Station Hill North Site. Section 106 - Energy Responses .

Station Hill North Site. RBC Energy Comments.

This document summaries the comments received for the 192032/HYB - Station Hill - North Site - ENERGY STRATEGY.

Figure 1

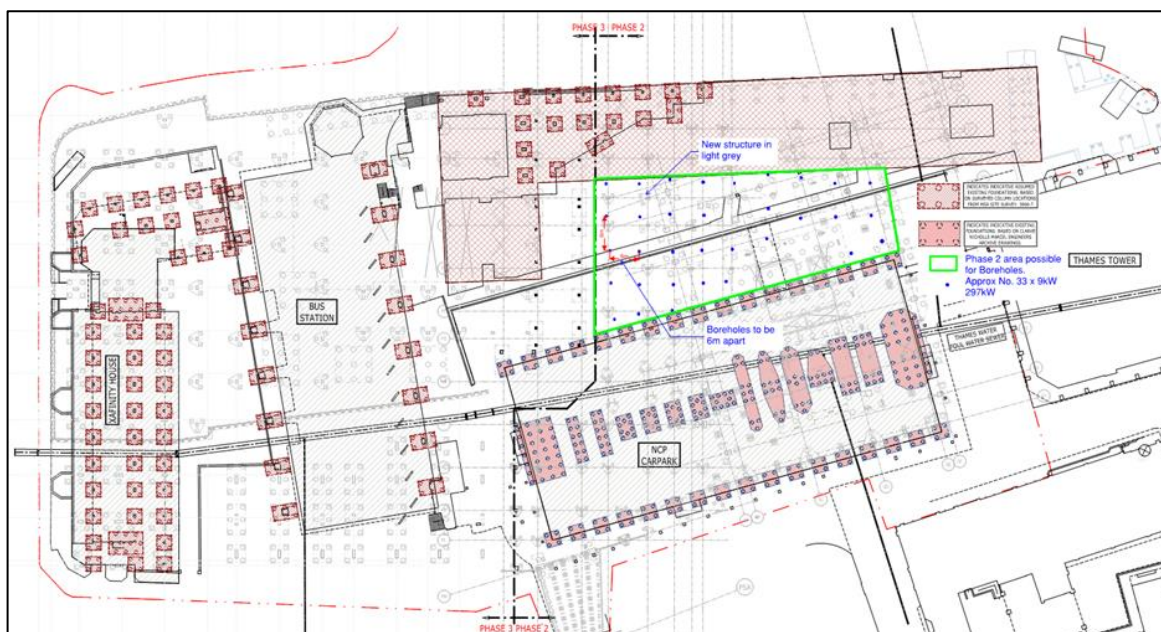
1. **RBC:** The applicant needs to provide further evidence why GSHP, which would normally be expected to result in better carbon reductions, has been omitted in Phase 2 (and not confirmed in Phase 3). This evidence may be in the form of, for example, detailed spatial analysis of GSHP plant and boreholes in relation to the wider Station Hill Phase 2/3 sites. This should be more detailed evidence than that which was provided in the planning application's energy statement.

Initial HL Response: Coordinated studies have been carried out to review the possibility of using GSHP closed loop system.

The drawing indicated below (See Figure 1) highlights the extent of existing foundations and utilities such as the Thames Water sewer on site, the majority of which cannot be removed, considering that a minimum distance of 6m between each borehole is required this will limit the space where boreholes can be located. The space in green indicates the available area that could potentially be used, this works out at approximately 33No. boreholes. If the boreholes were 150m deep, it should be possible to extract 9kW per borehole, this gives approximately 300kW maximum capacity from the GSHP network. This only provides 10% of the overall required load for the building, making this option not viable for the scheme.

Figure 2

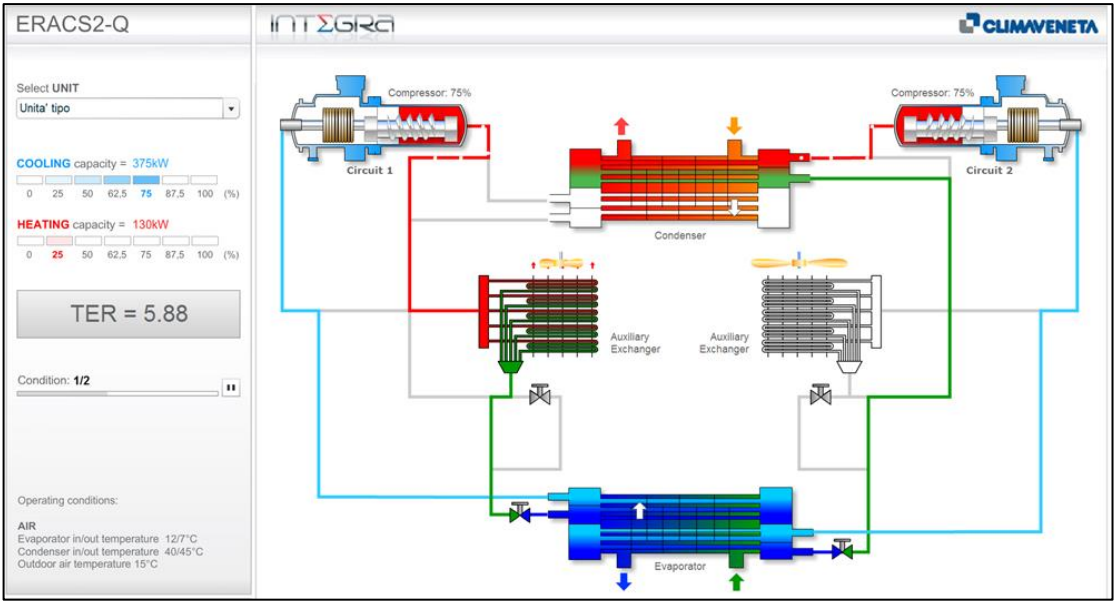
3. **RBC:** GSHP systems are generally more efficient than ASHPs. The Applicant should provide evidence to quantify the extent to which simultaneous heating/cooling demand may in fact result in similar annual efficiencies as has been suggested.

Figure 2 is of the building with a cooling demand 75% and heating demand 25%. The image shows some waste heat is still rejected to atmosphere.

Figure 4

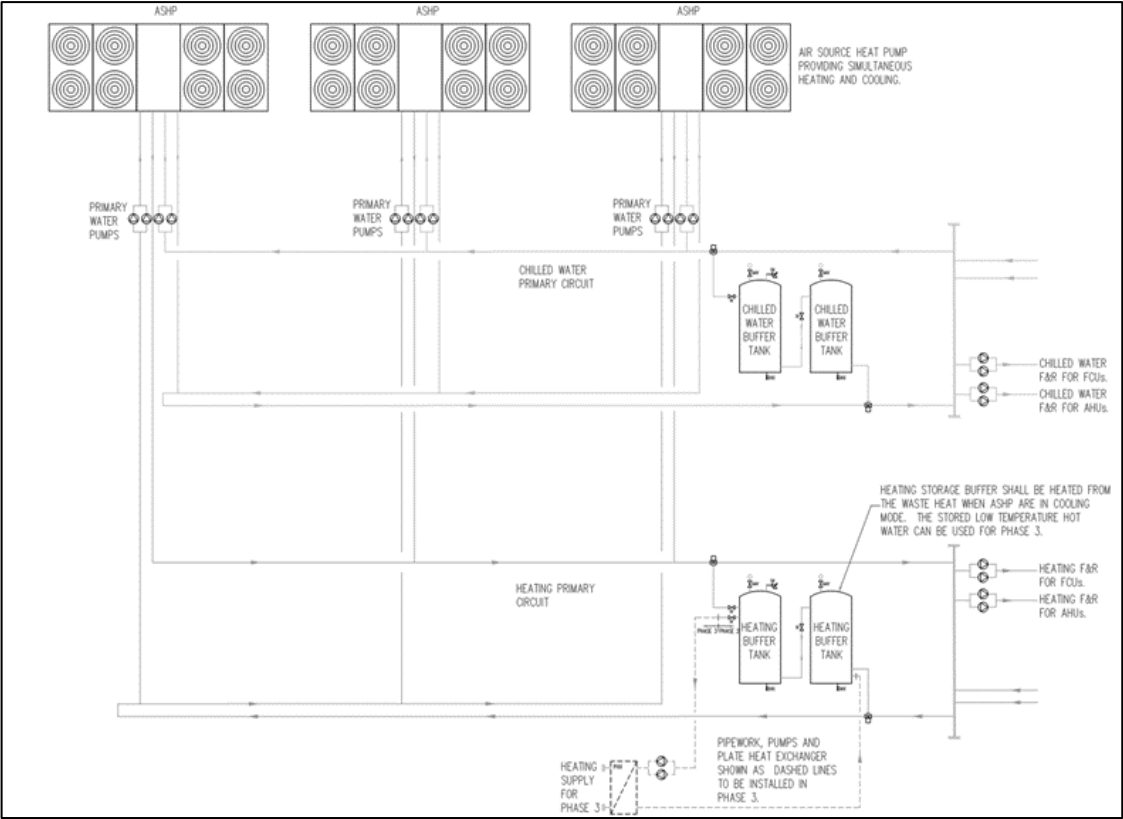
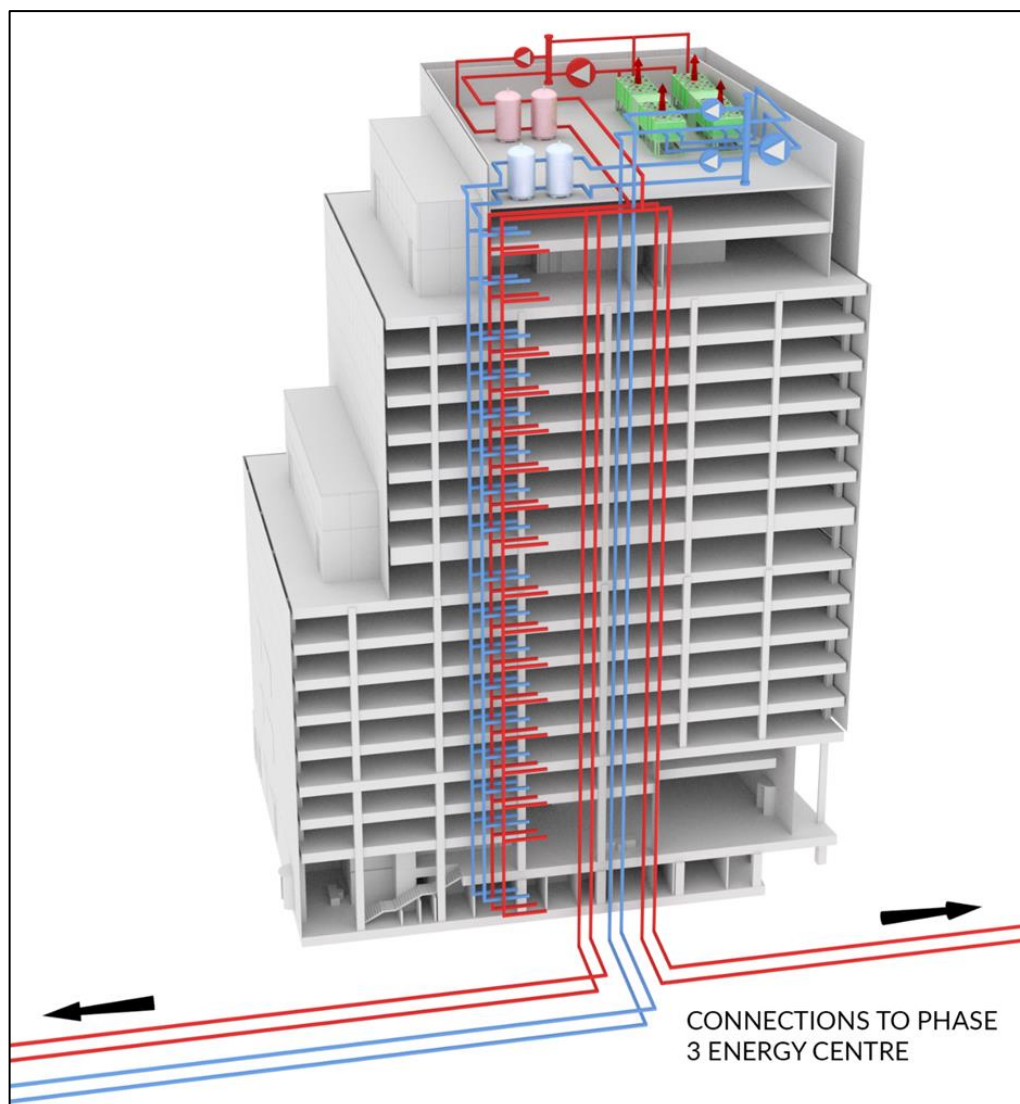
The applicant should engage further with the Council and Element Energy to ensure that adequate provisions are put in place to facilitate future connection of the Station Hill development to a wider area DH scheme. For example, this might include agreeing a position for connecting pipework to be laid to and capped off, ready for later connection. This should address the neighbouring sites referred to in the SPD.

The pipework shall be extended from the buffer vessel in Phase 3 with pumps and plate heat exchanger also being installed in Phase 3. The below shows the concept schematic of the system showing how the heat can be used by Phase 3

Figure 6

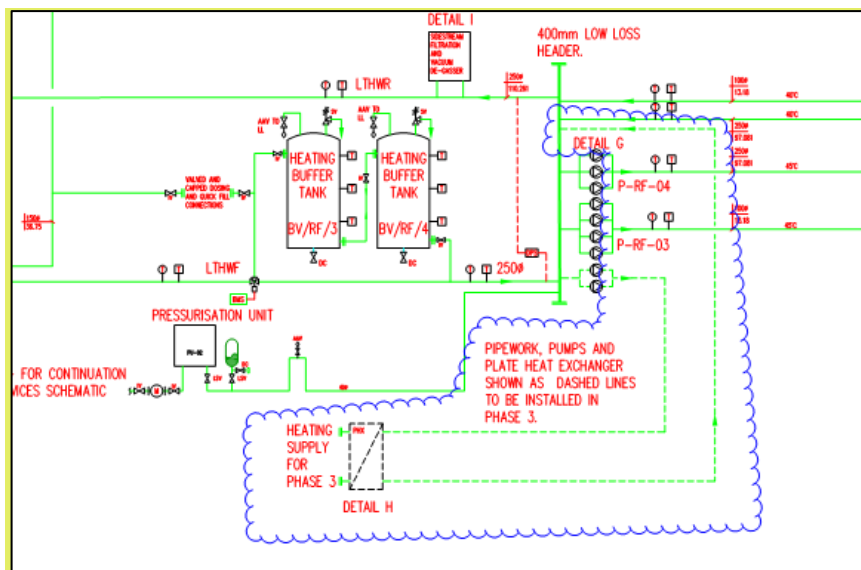
Further RBC/ EE Comments (08/07/20): (No. 6) Further narrative on future connection provision for Phase 3.

The future connection and PHX in dashed lines in the schematic SHRN-HL-BG-SM-M-590-0002, specific area clouded in Figure 6 (the full drawing is located in Appendix 3)
